ALLEGHENY COUNTY SANITARY AUTHORITY

CONTRACT NO. 1729 G, E, H, P

EAST HEADWORKS

ADDENDUM NO. 8

**530-A-26
EAST HEADWORKS
WALL SECTIONS**

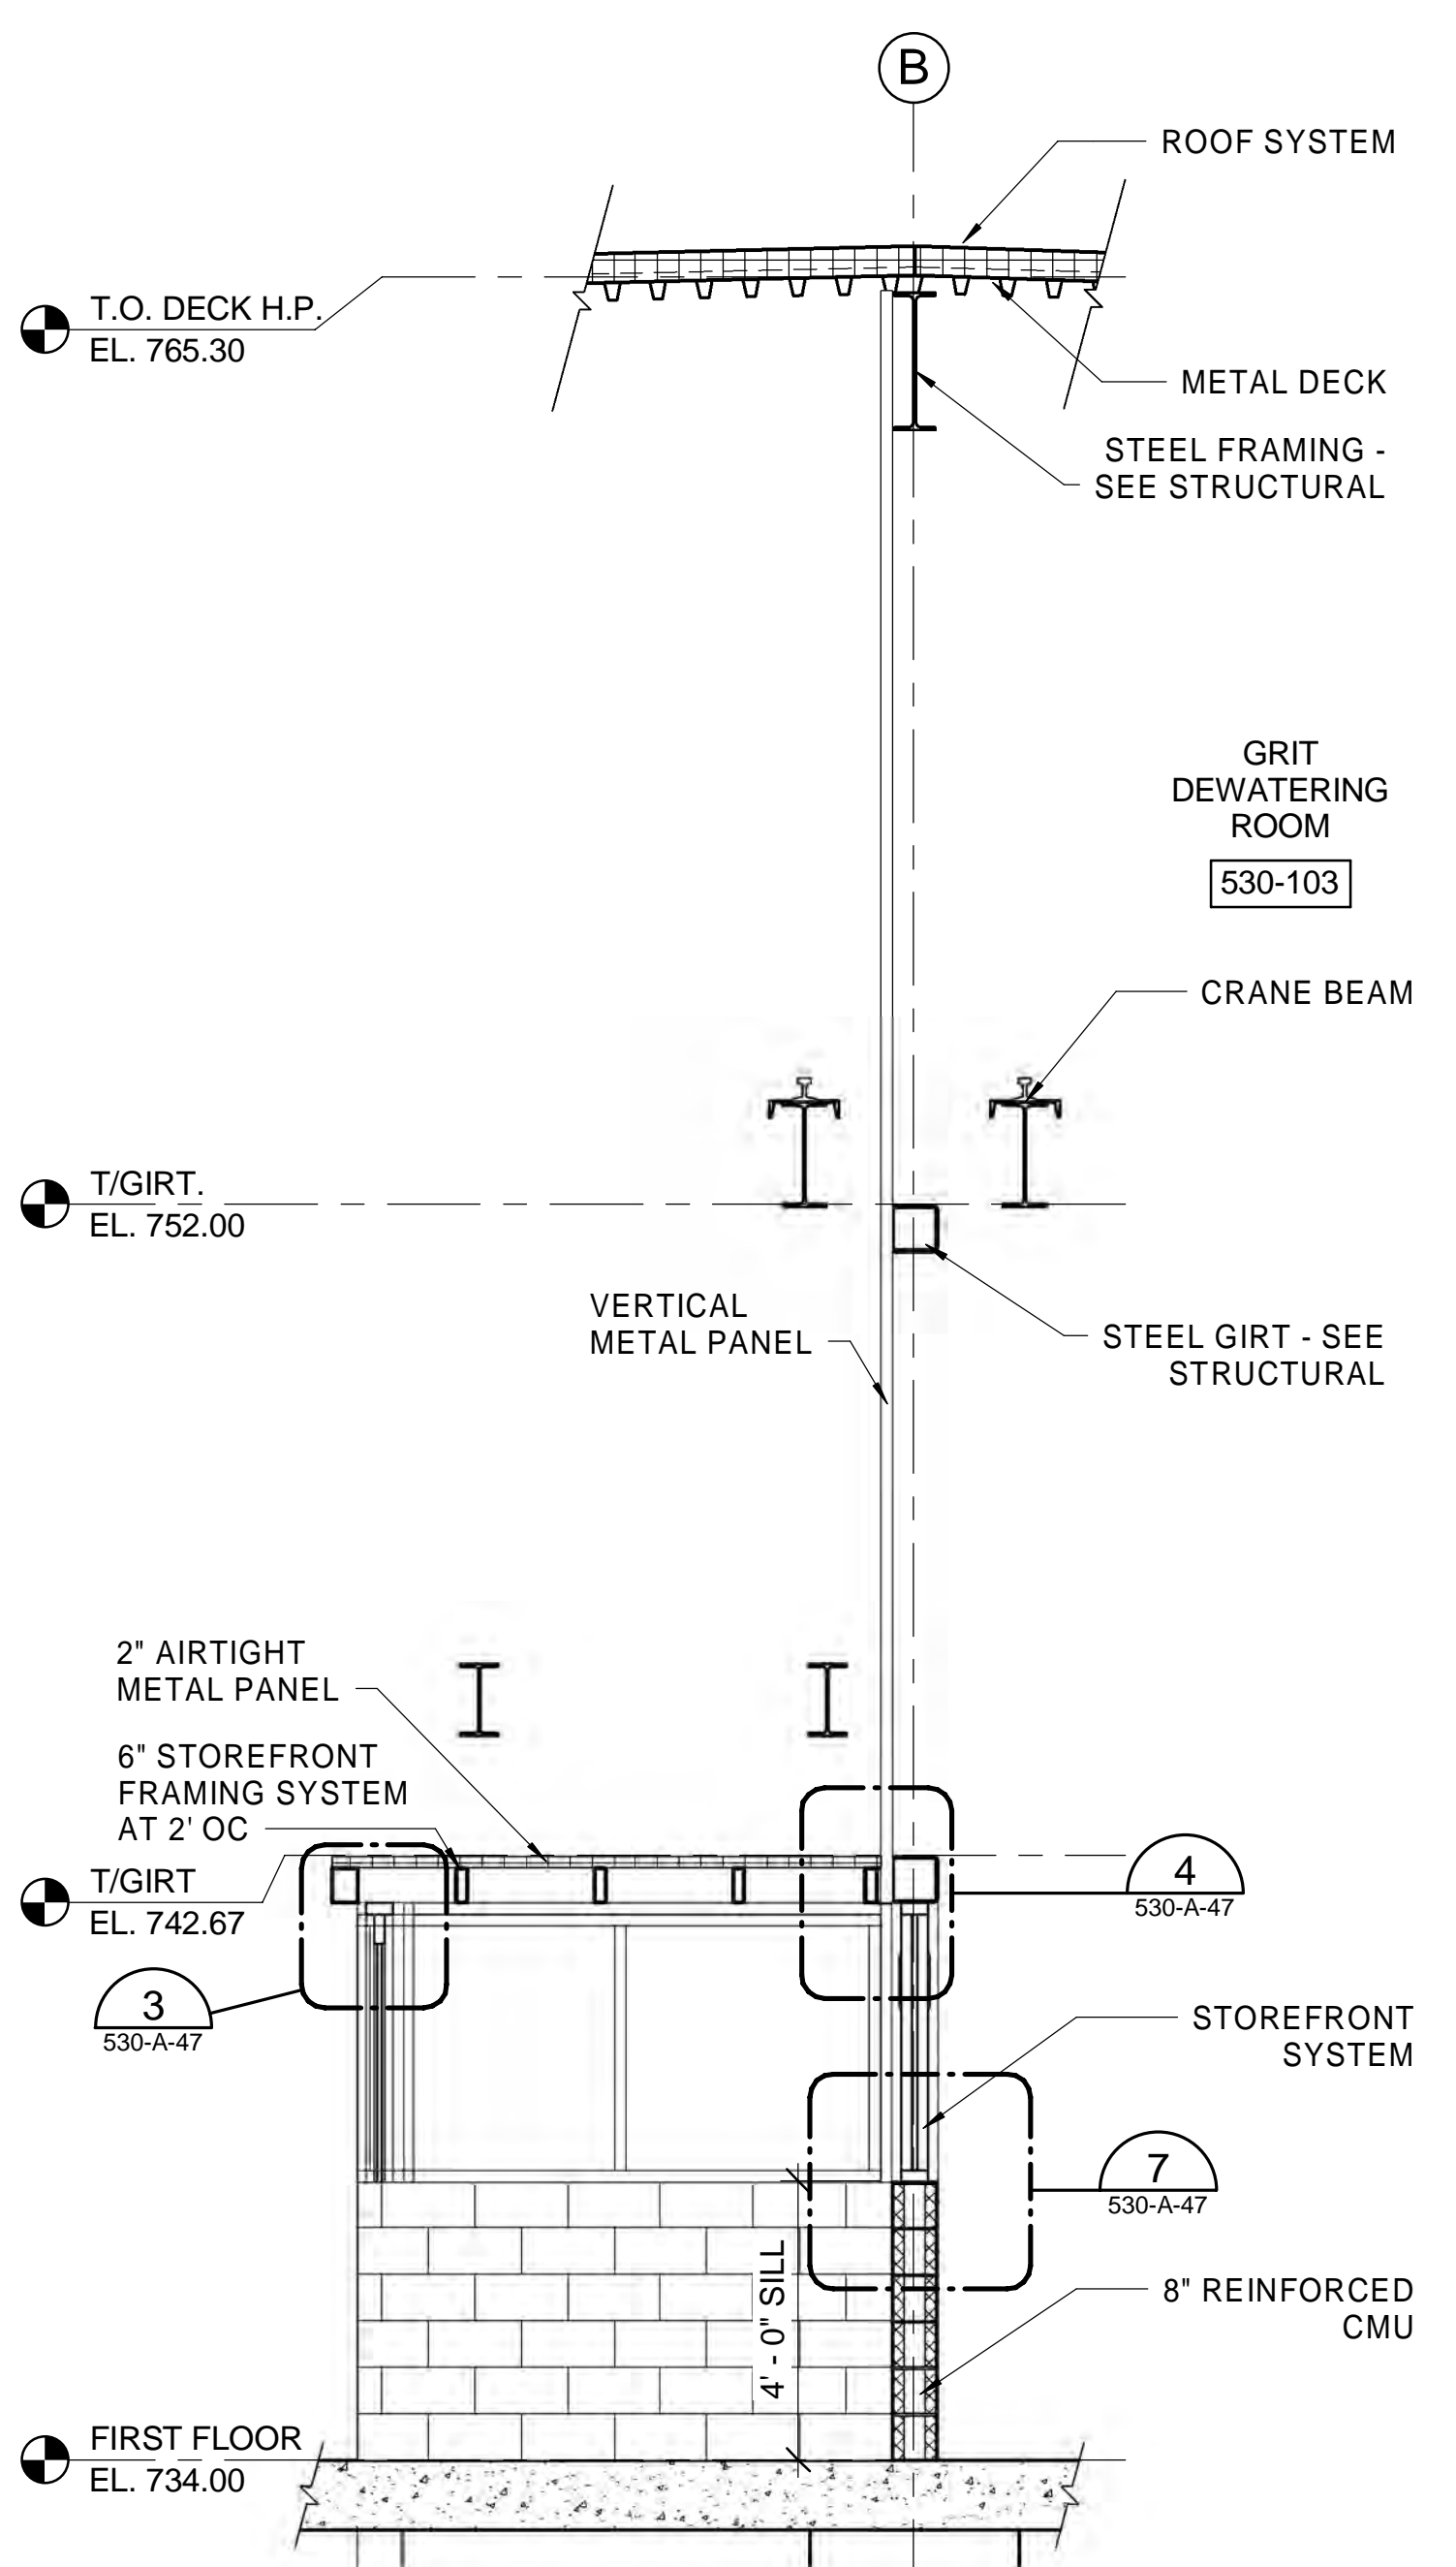
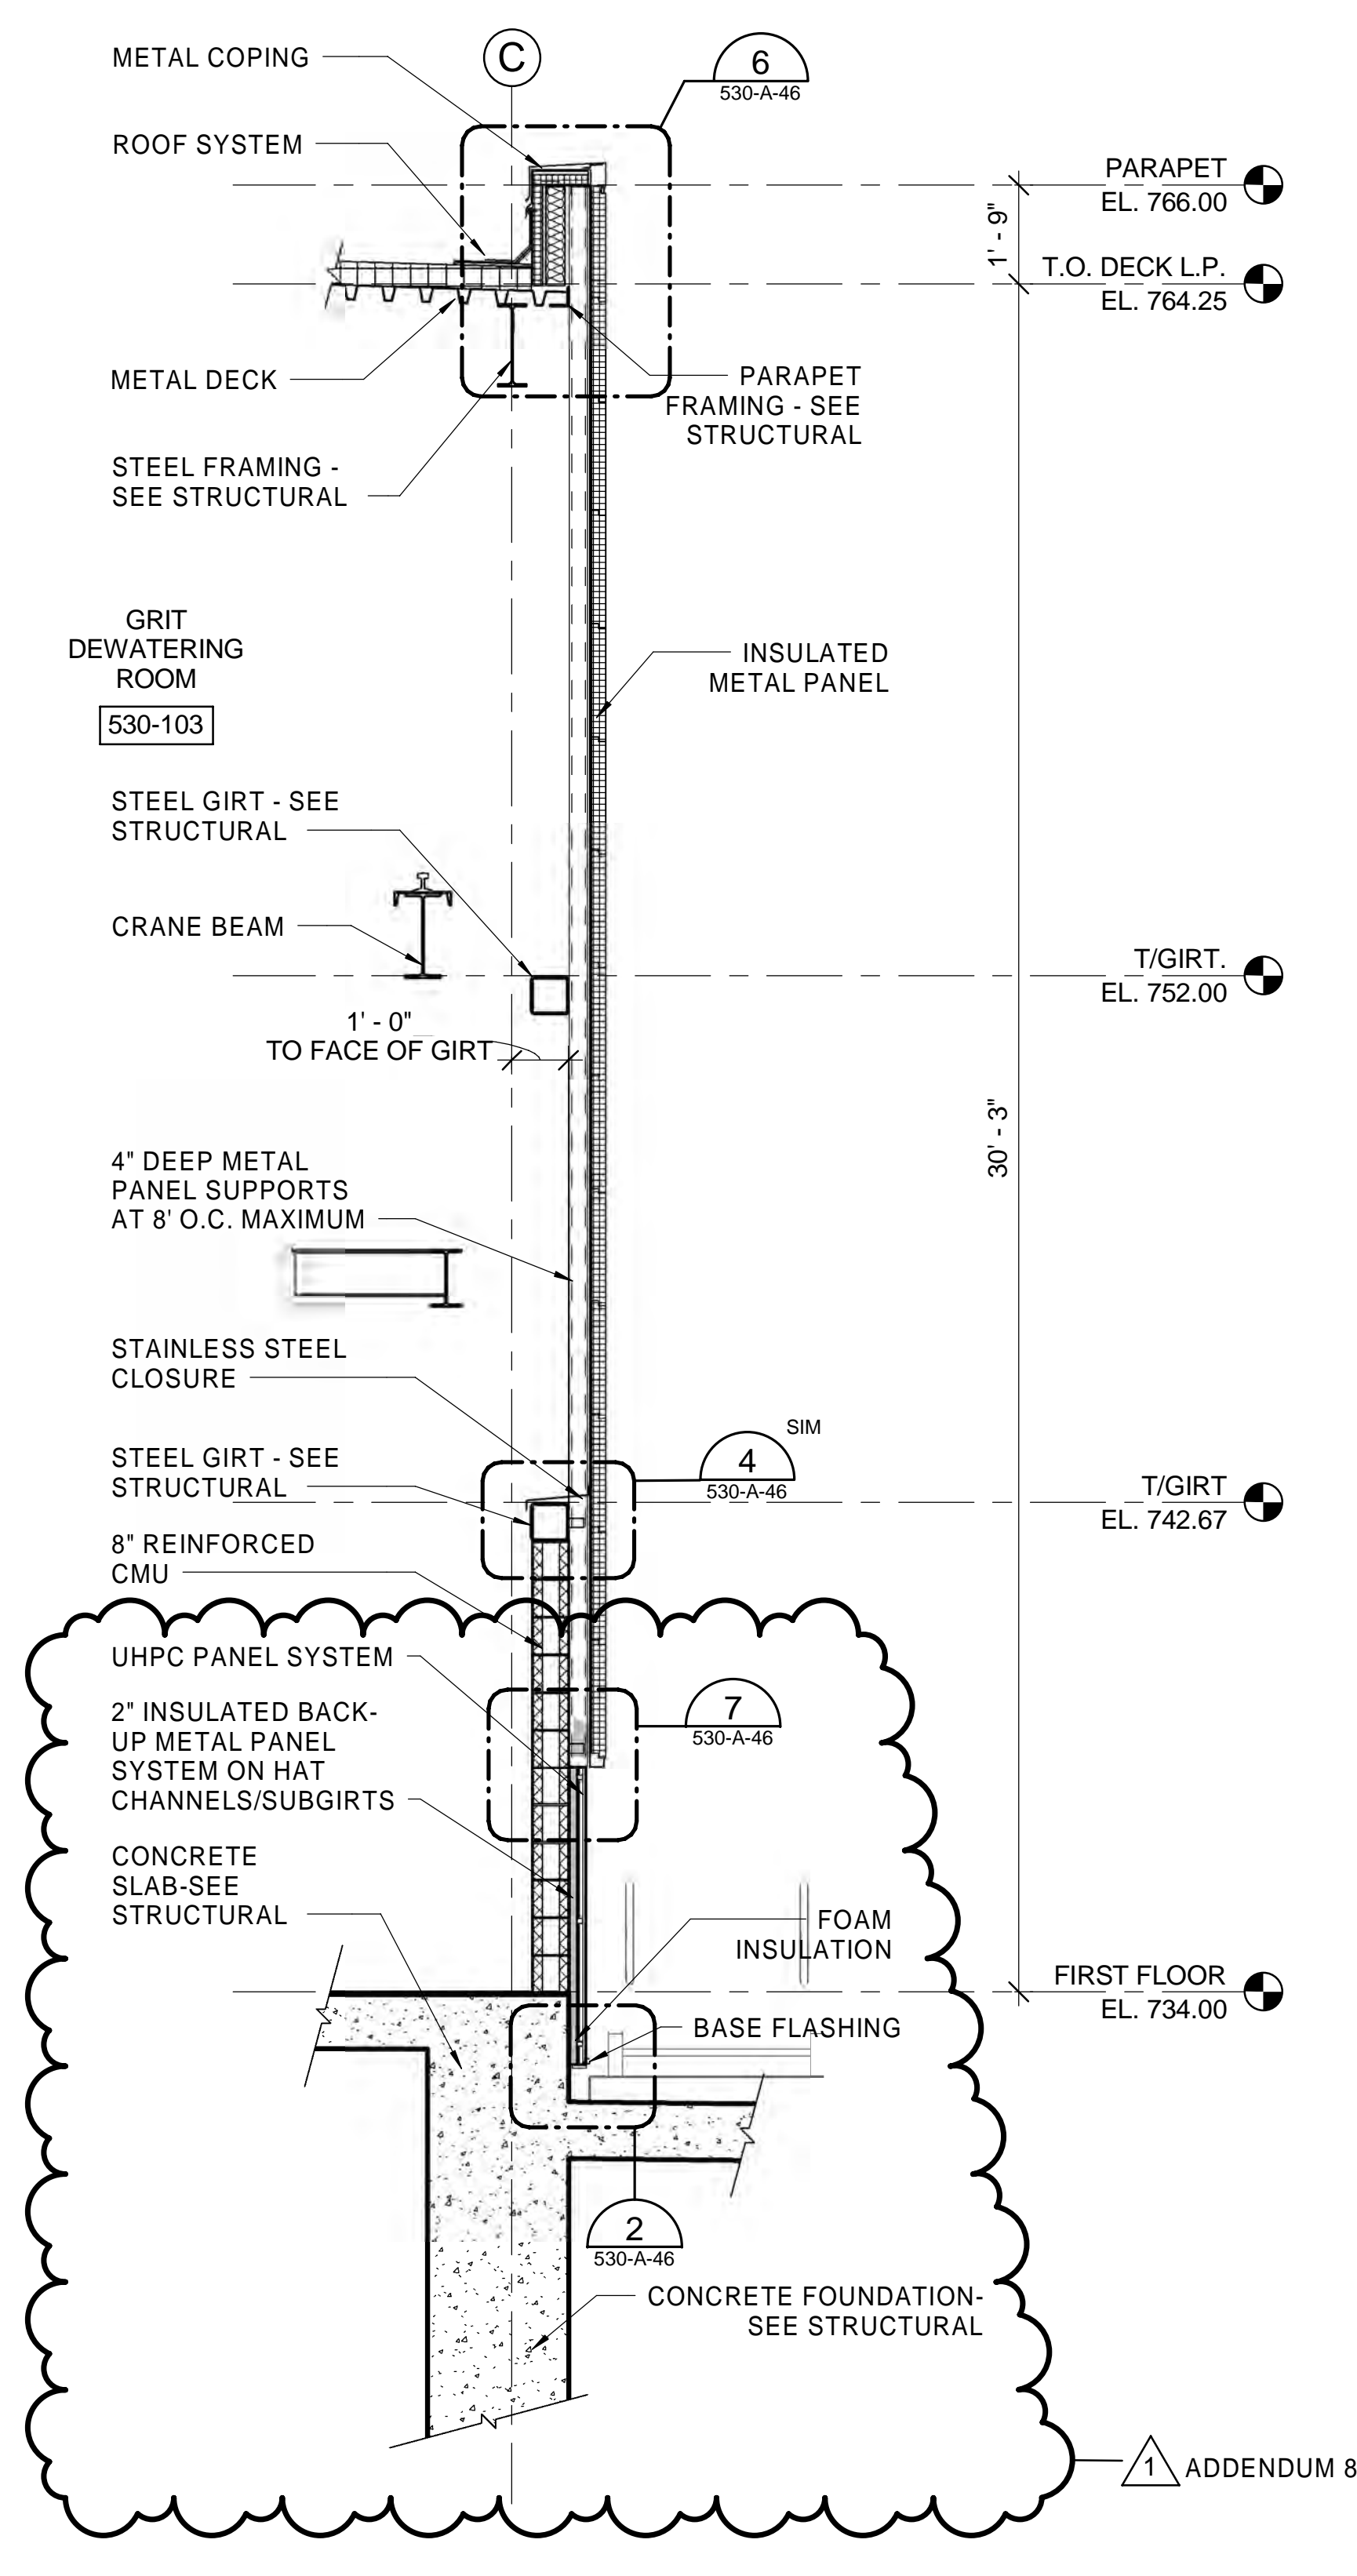
180. **QUESTION:** Reference wall section 1 on sheet 530-A-26: This section shows the UHPC panels over "rigid insulation". Other similar wall sections, such as 3 on sheet 530-A-26, identify the insulation as "foam insulation". These sections and other similar wall sections refer to details 2 and 7 on sheet 530-A-46. These two details, however, show the UHPC panel system installed over the 2" insulated back-up metal panel system on hat channels. Please clarify if the UHPC panels are to be installed over rigid foam insulation or the insulated back-up metal panel system. Also, we do not believe details 2 and 7 on sheet 530-A-46 show all of the necessary sub-framing components for both the back-up metal panel and the UHPC panel systems.

RESPONSE: The UHPC panel system is installed over 2" insulated back-up metal panel system on hat channels per Details 2 and 7 on 530-A-46. The UHPC panels and back up panel manufacturers are responsible for providing the required panel supports, at spacing as required by the manufacturer. For the UHPC panel system, provide concealed attachment system per Specification Section 07 42 47, Part 2.3. For the 2" insulated backup panels, provide subgirts (hat channels) and panel attachment clips per Specification Section 07 42 17.10, Part 2.4.
